L-2018-223
10 CFR 54.17

Re: Florida Power & Light Company
Turkey Point Units 3 and 4
Docket Nos. 50-250 and 50-251
Turkey Point Units 3 and 4 Subsequent License Renewal Application Safety
Review - November 15, 2018 Public Meeting Action Item Responses

The purpose of this letter is to provide, as attachments to this letter, responses to the discussion topic action items assigned to FPL during the referenced public meeting. These responses revise and supersede (or supplement) the corresponding RAI and On-Site Regulatory Audit Follow-up Item responses in References 4, 5, 6 and 7.

Revise Figures 4.5-1, 2, 3, 4, 5, 6 pages 4.5-4 – 4.5-9 as follows:

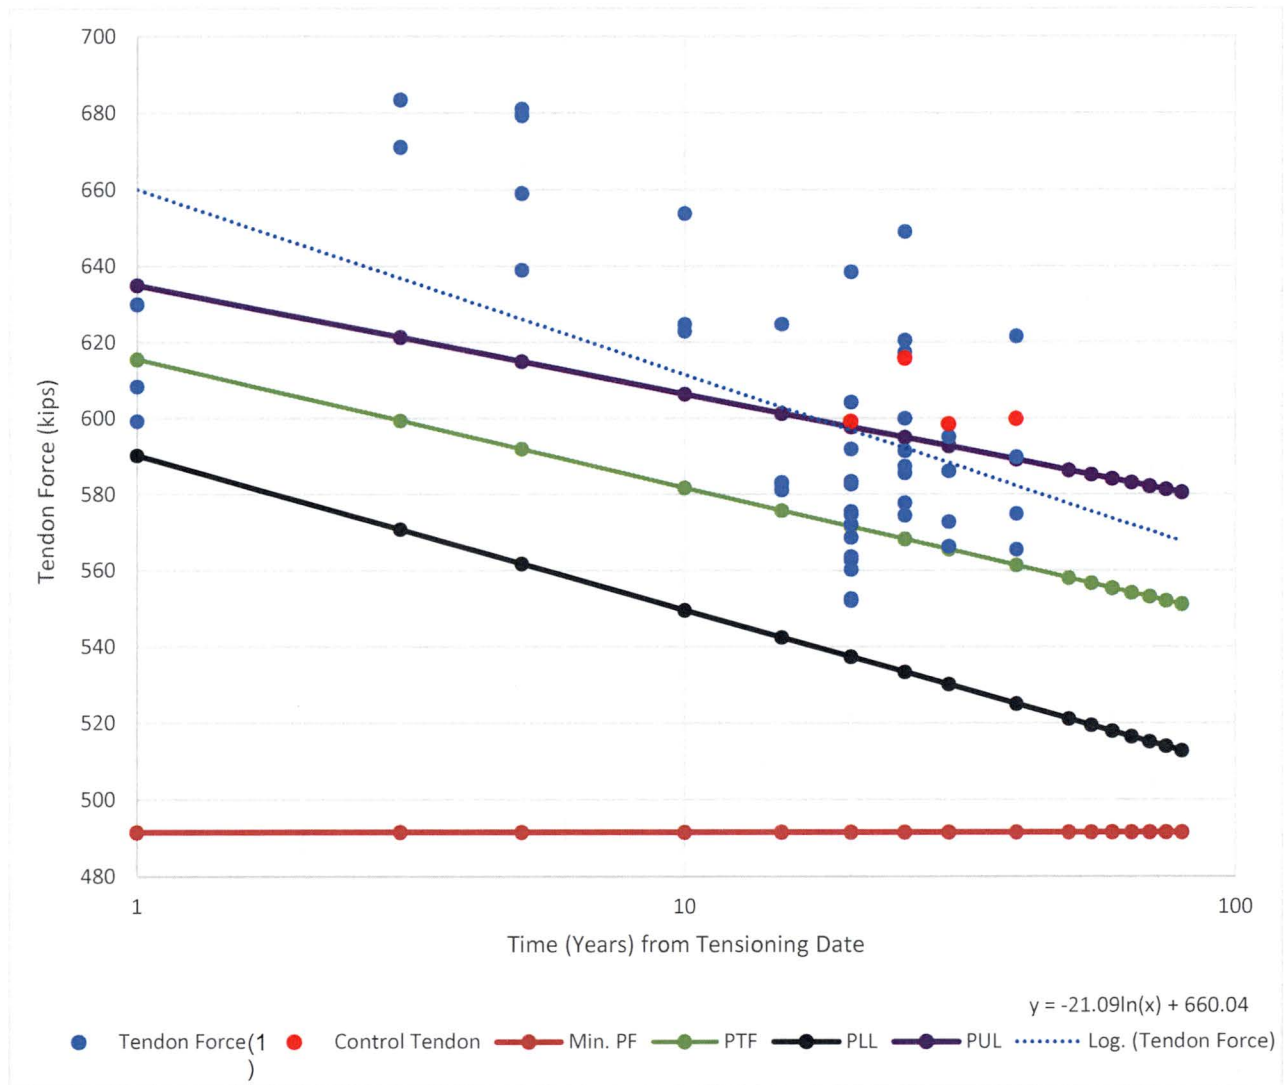
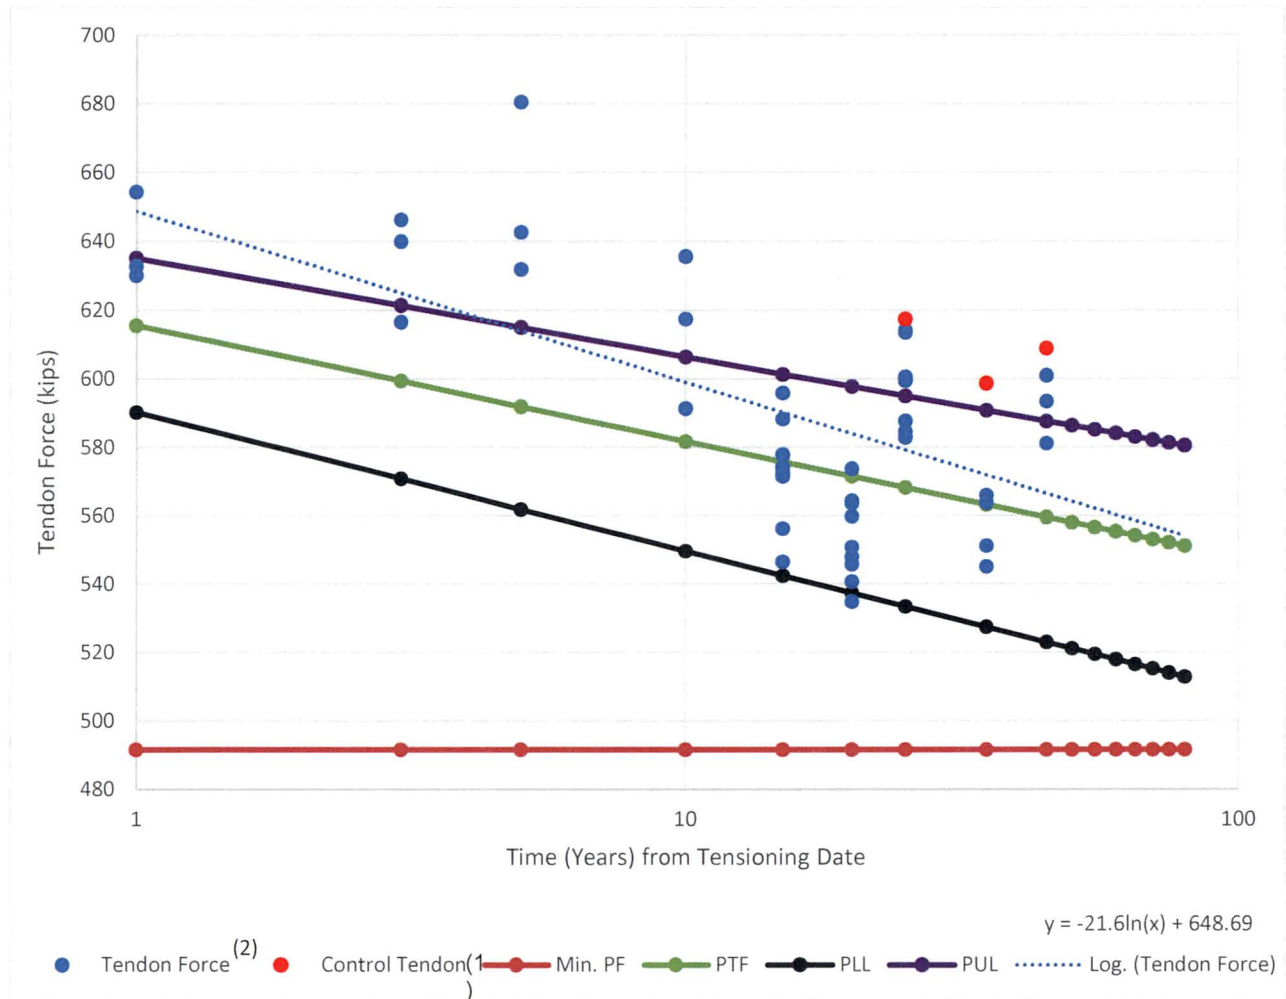
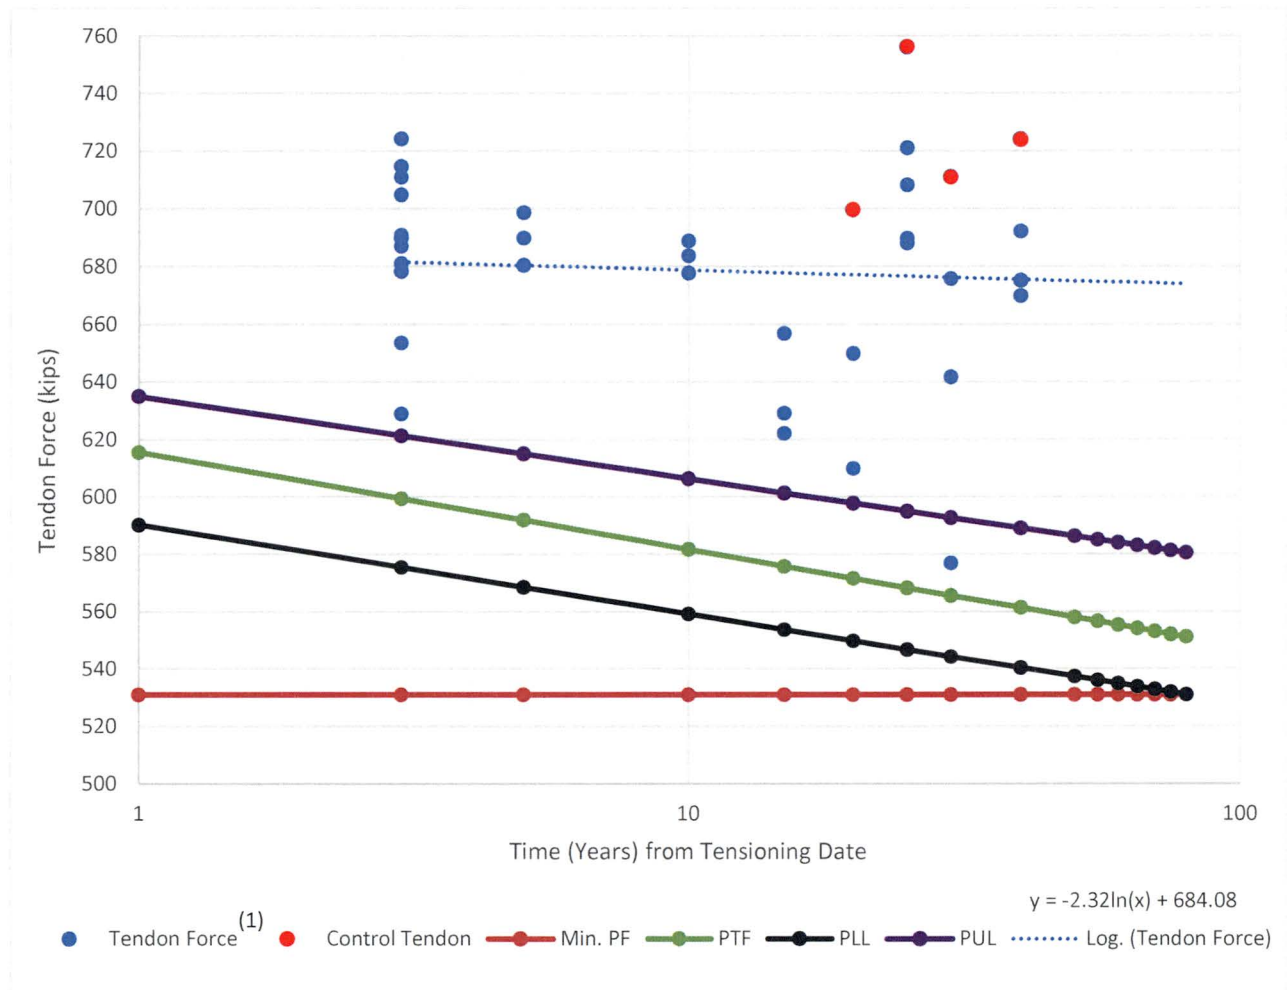
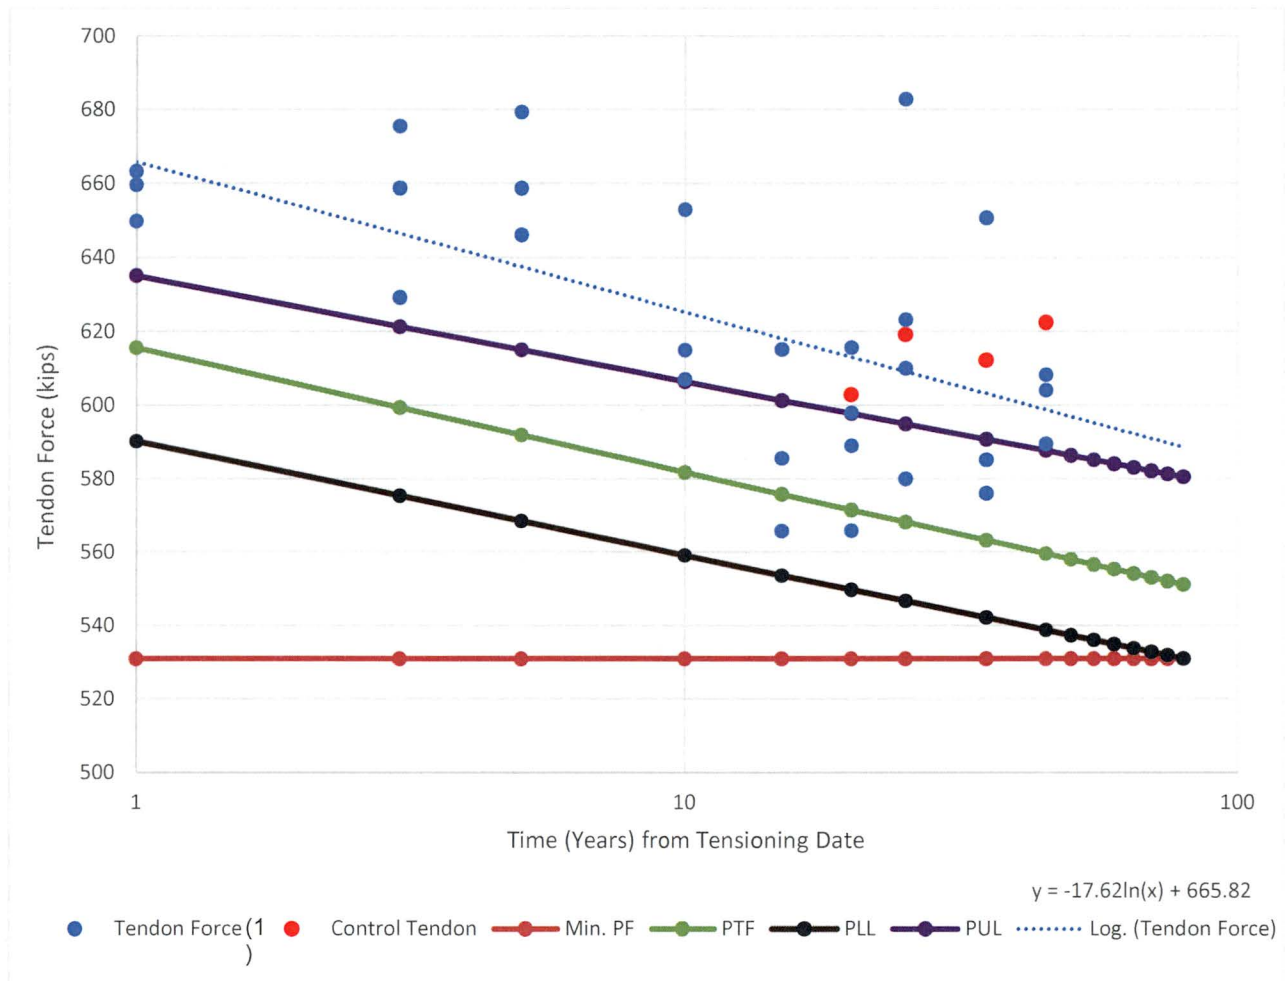
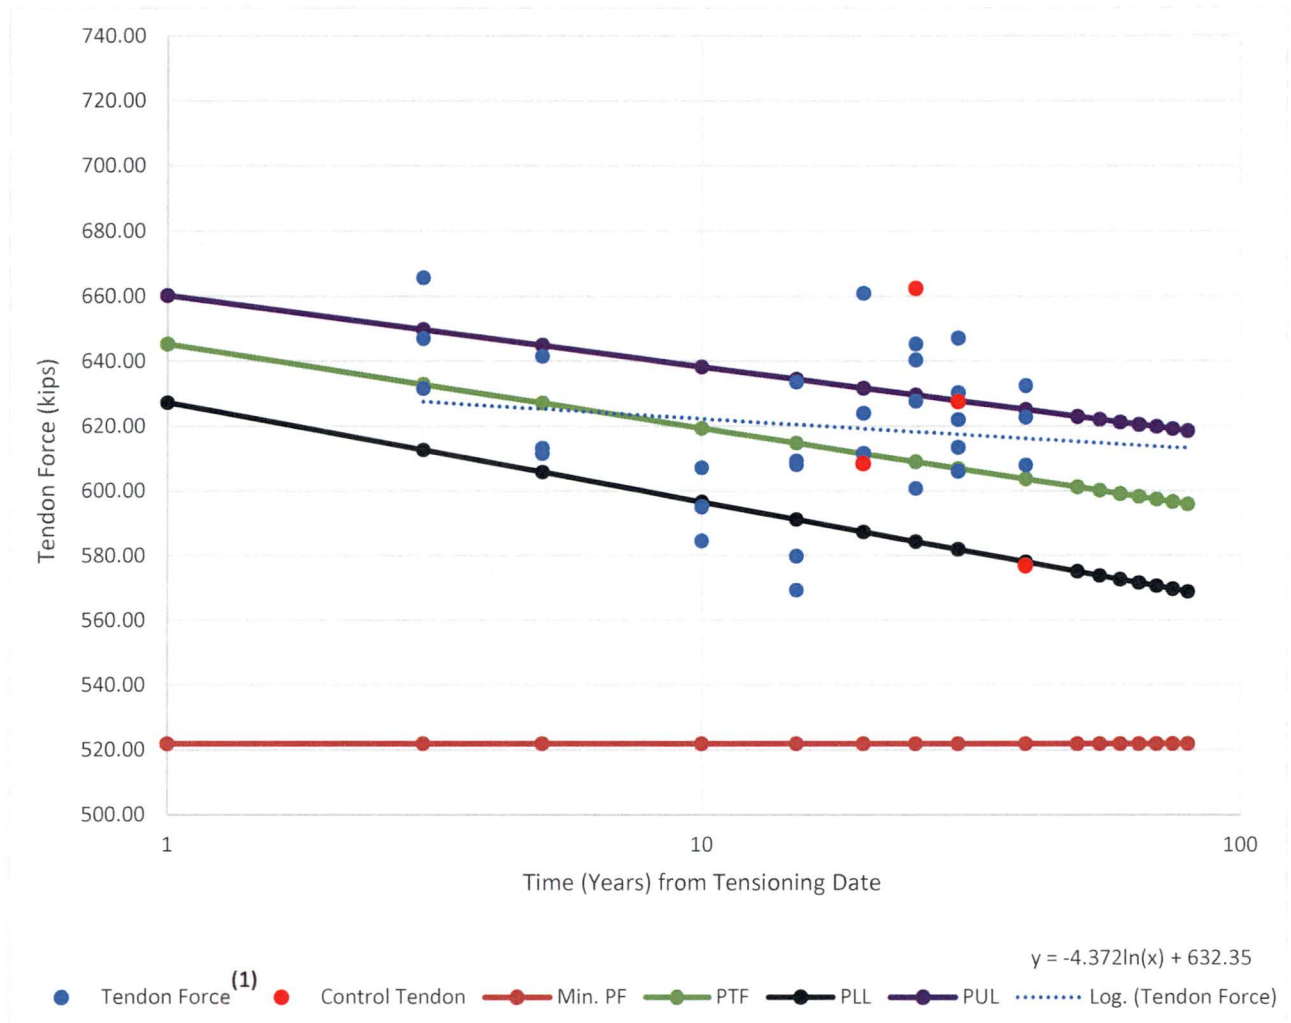
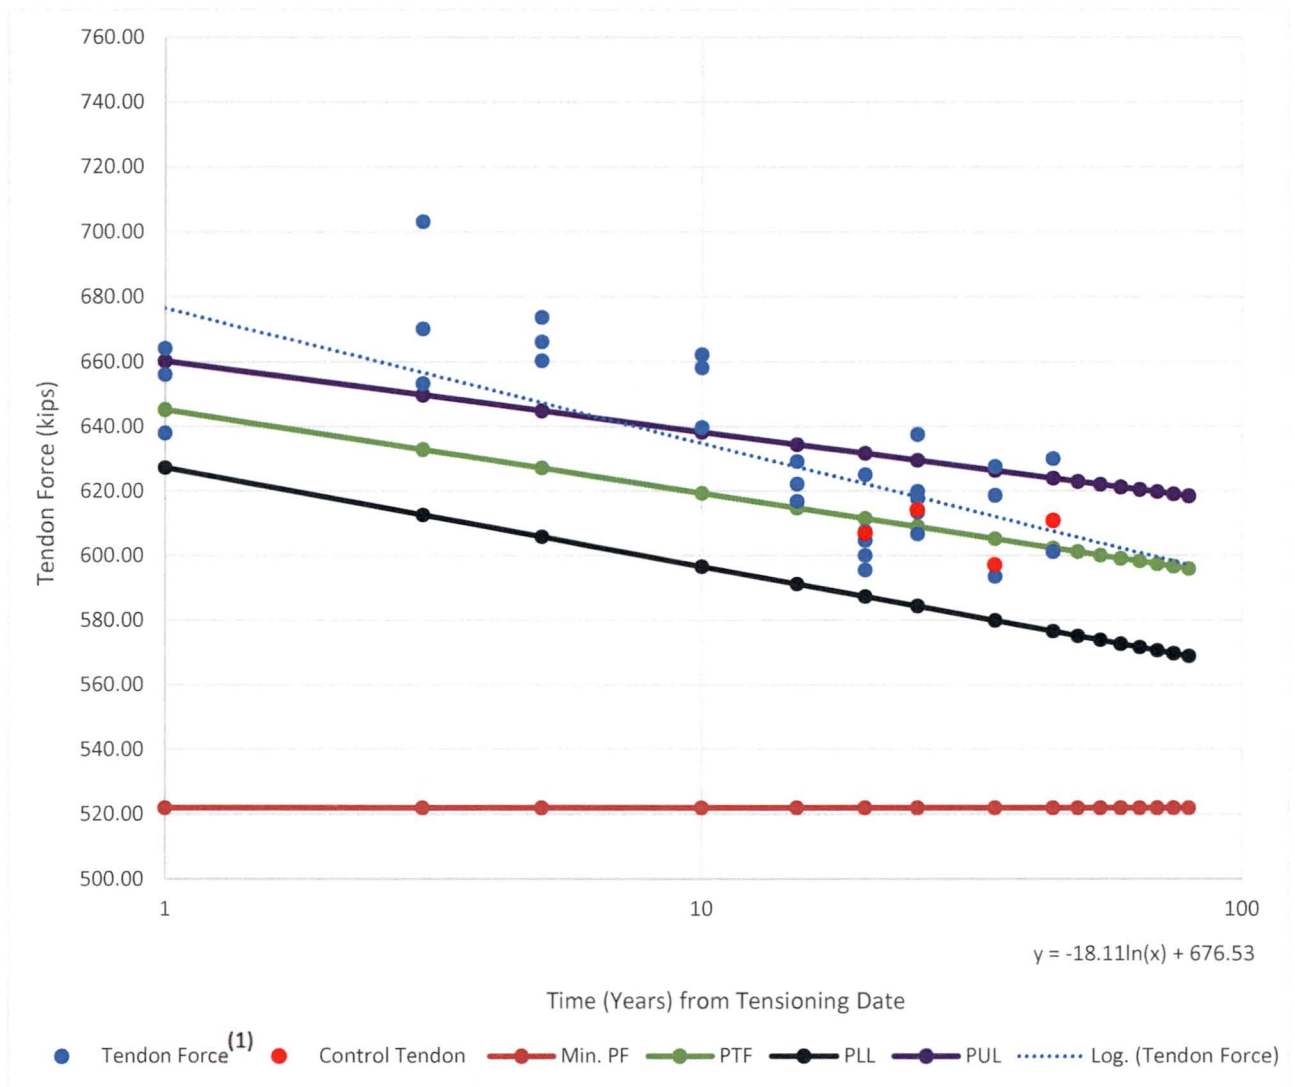
During the NRC site audit at Turkey Point from August 30, 2018 questions were raised regarding SLRA Section 4.5 Concrete Containment Tendon Prestress TLAA and the supporting calculations. These questions included clarification of:

This response revises the audit follow-up response in Attachment 2 of FPL's November 2, 2018 response (Reference 1) as a result of discussions during the NRC public meeting on November 15, 2018 (Reference 2) related to further clarifications regarding the Concrete Containment Tendon Prestress TLAA. That response is superseded in its entirety for clarity. The conclusions in Reference 1 Attachment 2 were carried forward unchanged in this revised response.

- Added statement in the calculation and SLRA Section 4.5 that the PLL is evaluated as a TLAA.
- The tendon surveillance for Units 3 and 4 were performed at one, three, and five years after the containment Initial Structural Integrity Test, and every five years thereafter. In response to the NRC Final Rule 61 FR 41303 (Reference 4) which required implementation of the revised requirements for containment examination by September 9, 2001, FPL submitted proposed license amendments to incorporate the revisions to 10 CFR Section 50.55a(b)(2)(vi) (Reference 5). The revision to 10 CFR Section 50.55a(b)(2)(vi) states that ASME Section XI, Subsection IWL, as modified and supplemented by the requirements in Section 50.55a(b)(2)(viii), shall be used by licensees when performing containment examinations.
